# CONSTRUCTION OF FIRE STATION 15

26-C01265/GB

County of Hernando  
Construction of Fire Station 15

M-101

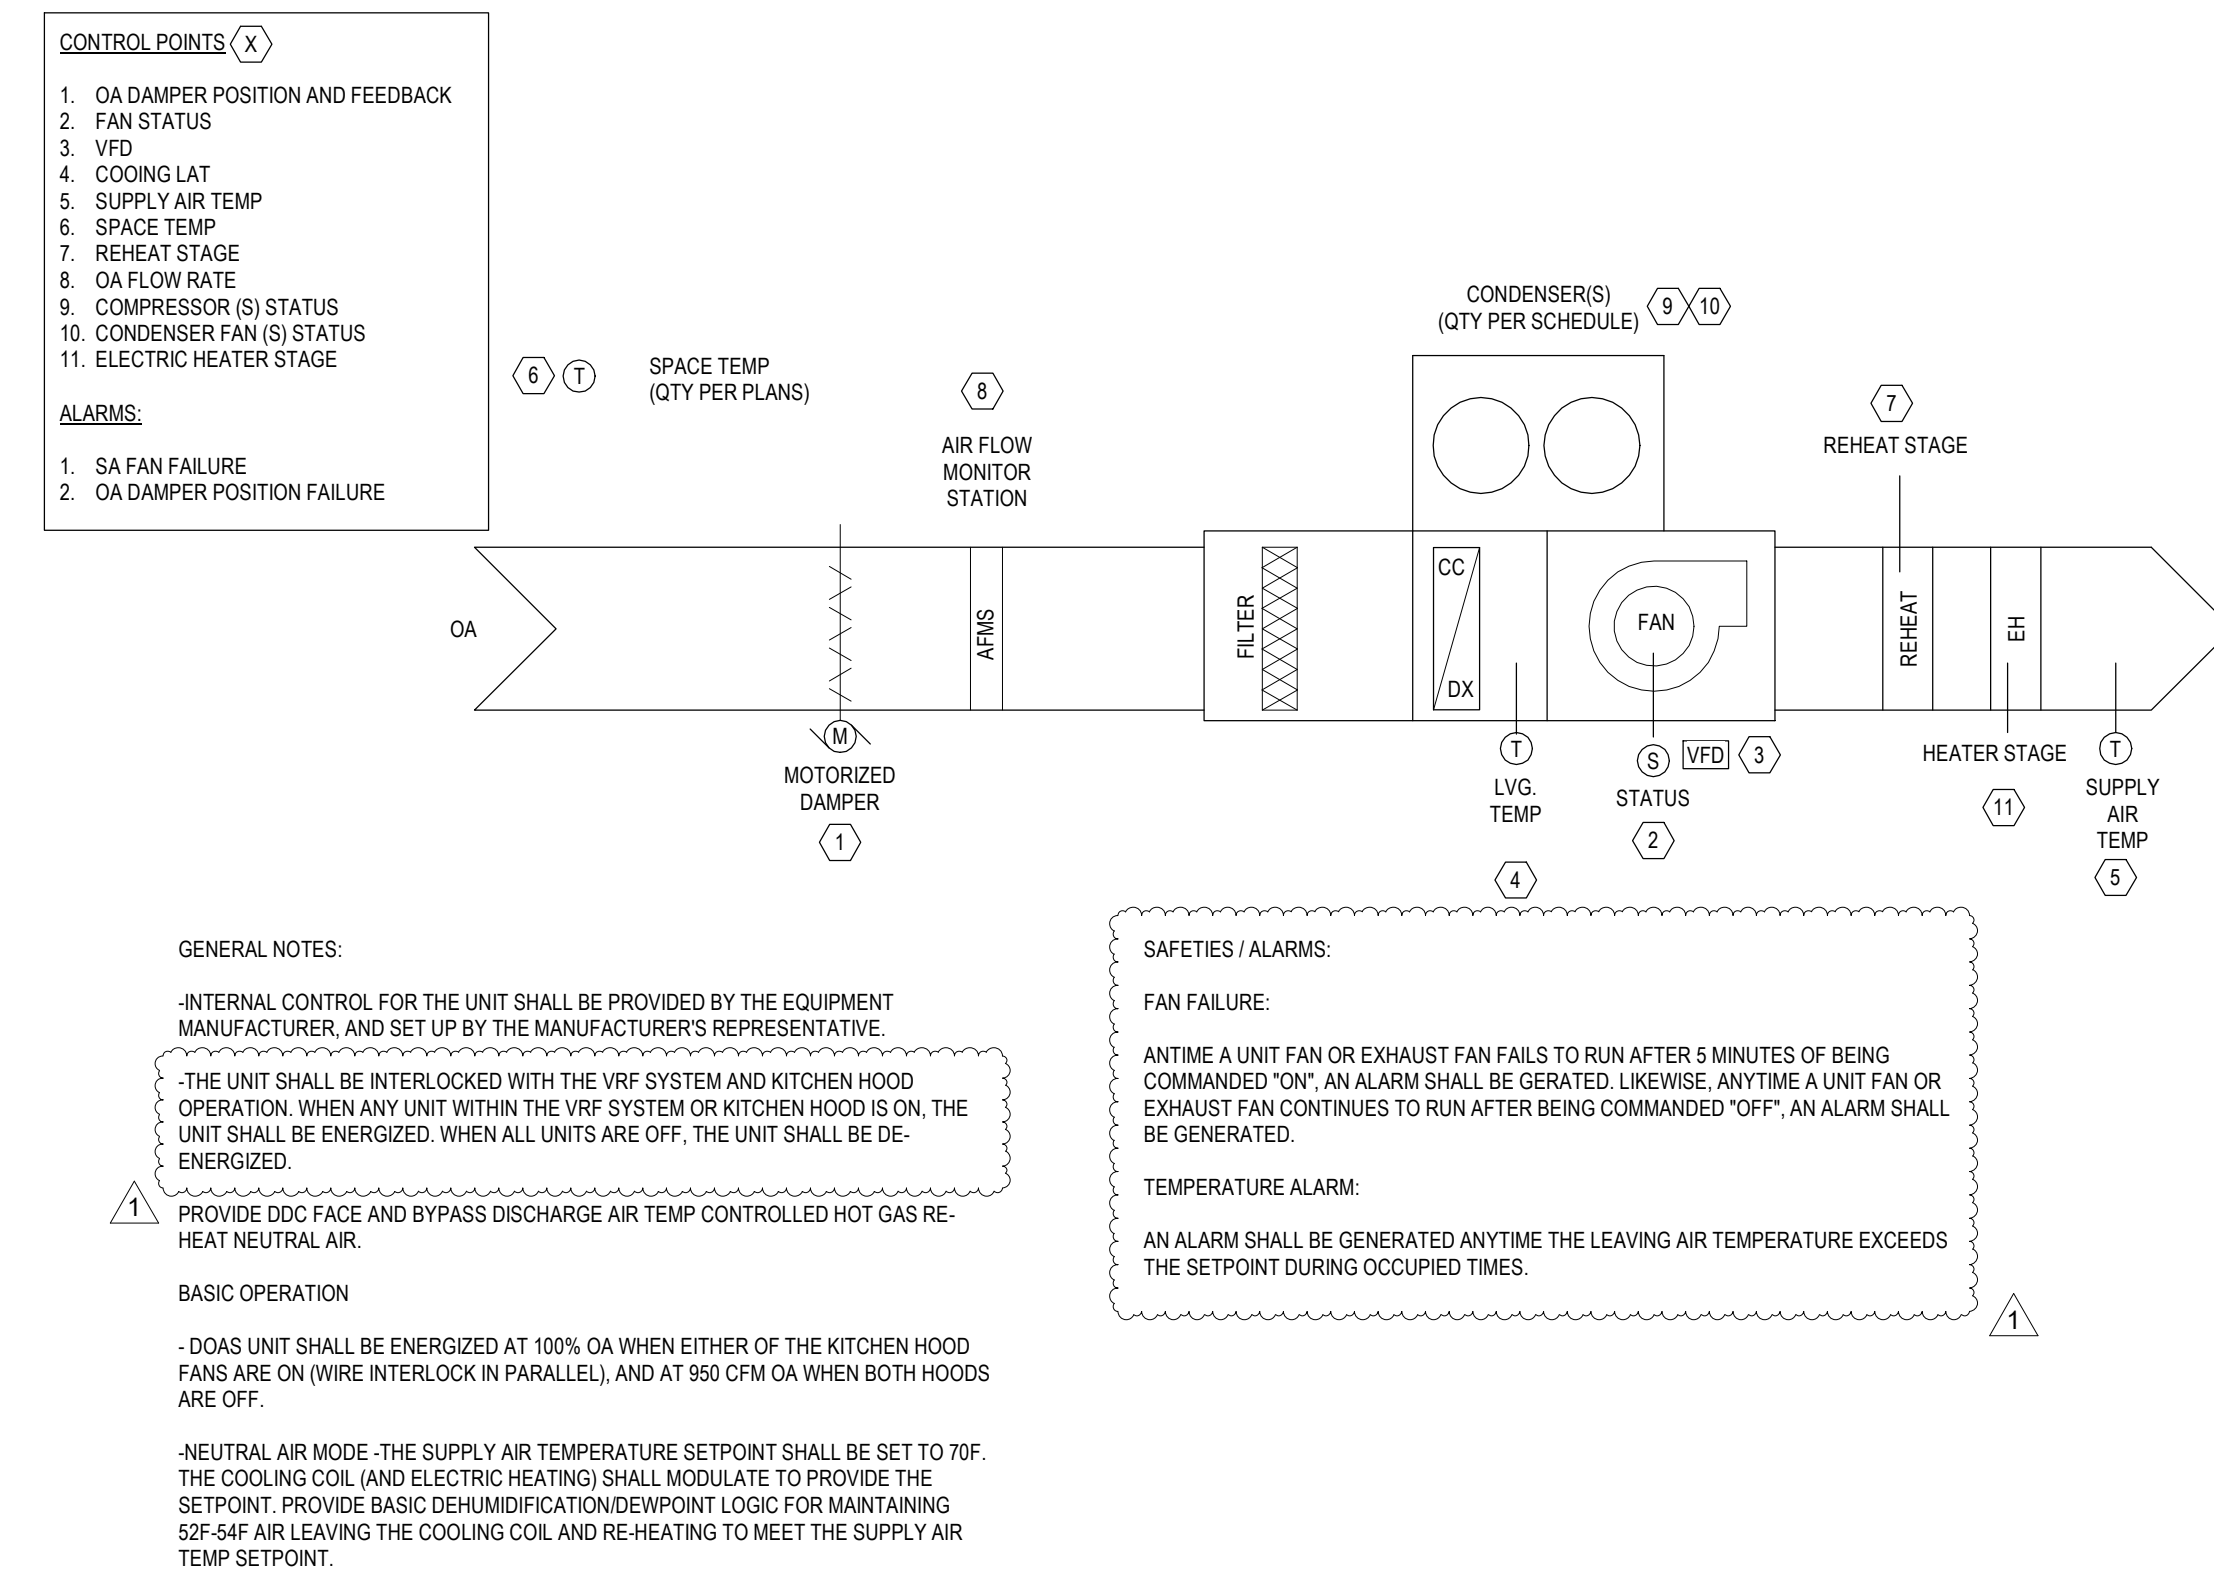
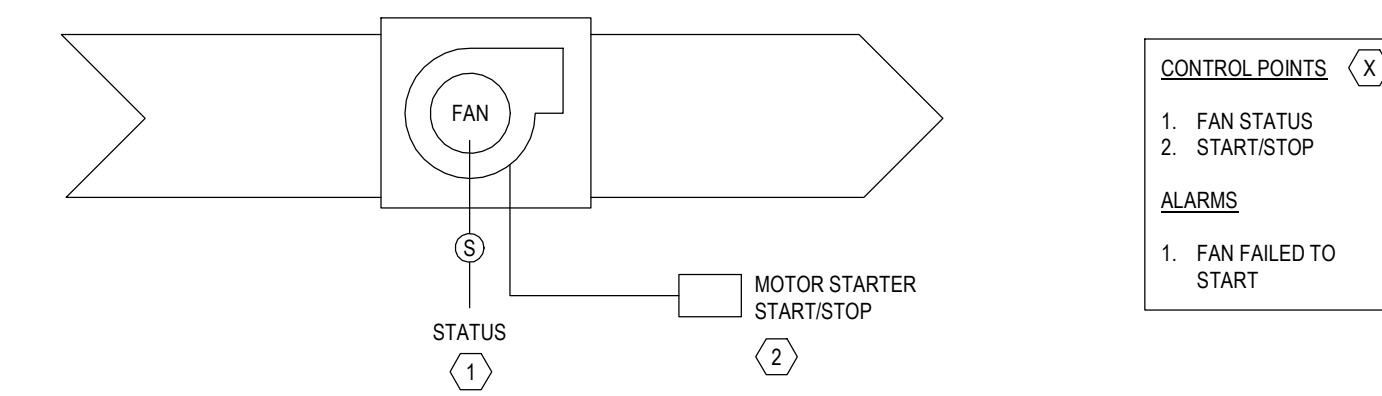
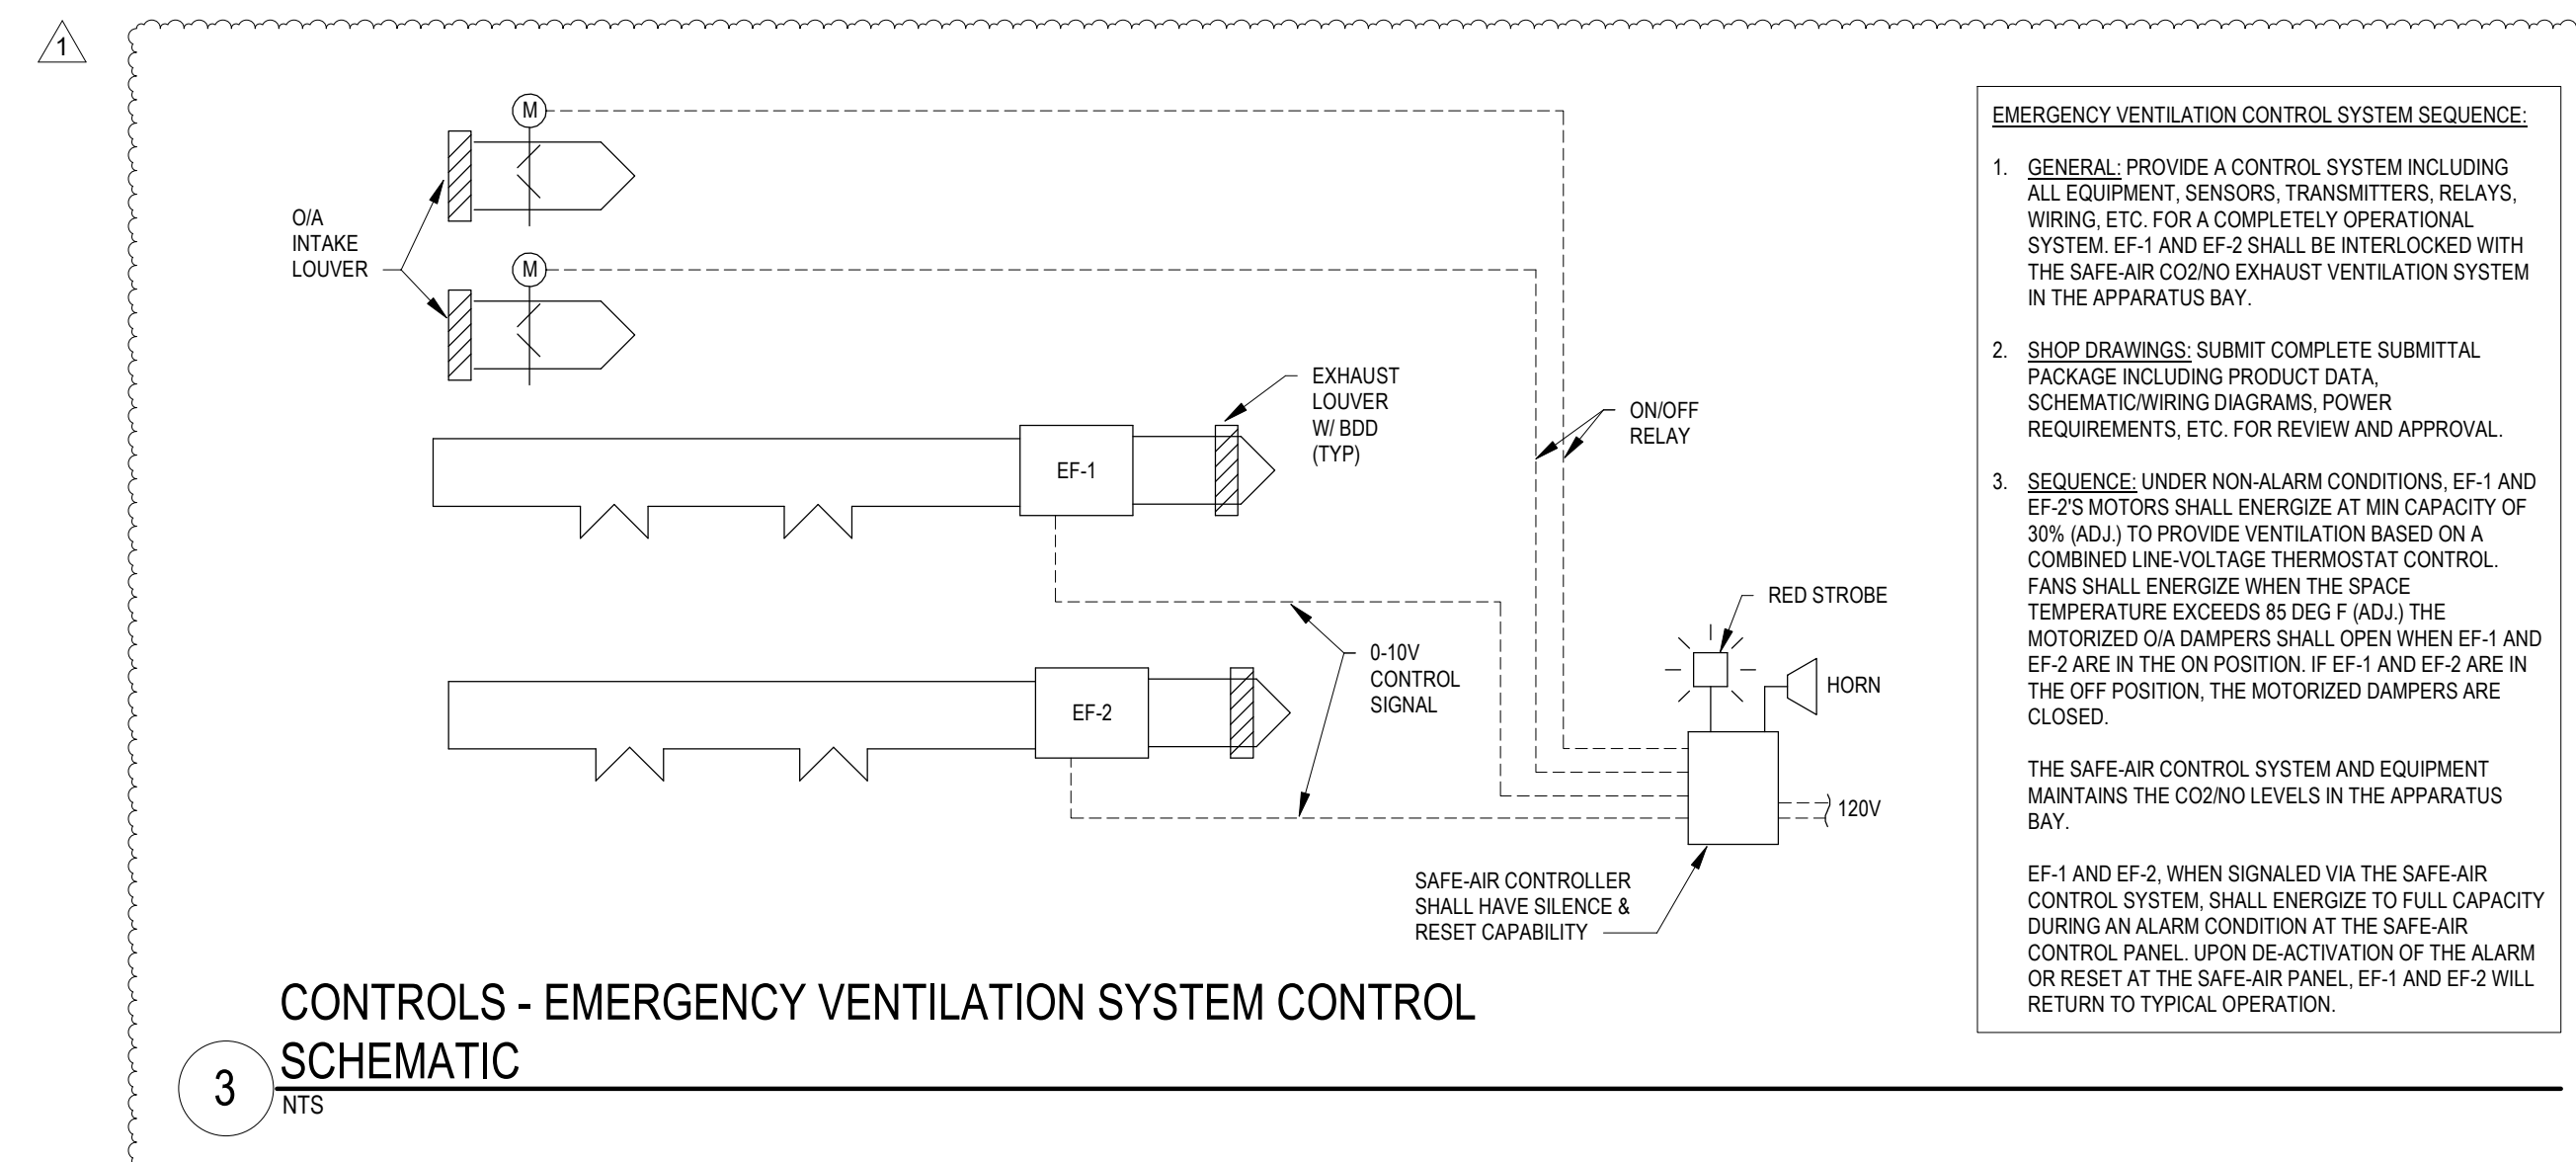
**37.Q. Sheet M-101 HVAC Keynote 11 calls for a Diesel Exhaust and CO detection system in the Apparatus Bay. Please provide details and specifications for this system. Please clarify, sheet M-701 Exhaust Fan Control Schematics EF-1 and EF-2 references a source capture system and says that EF-1 and EF-2 are controlled by thermostats.**
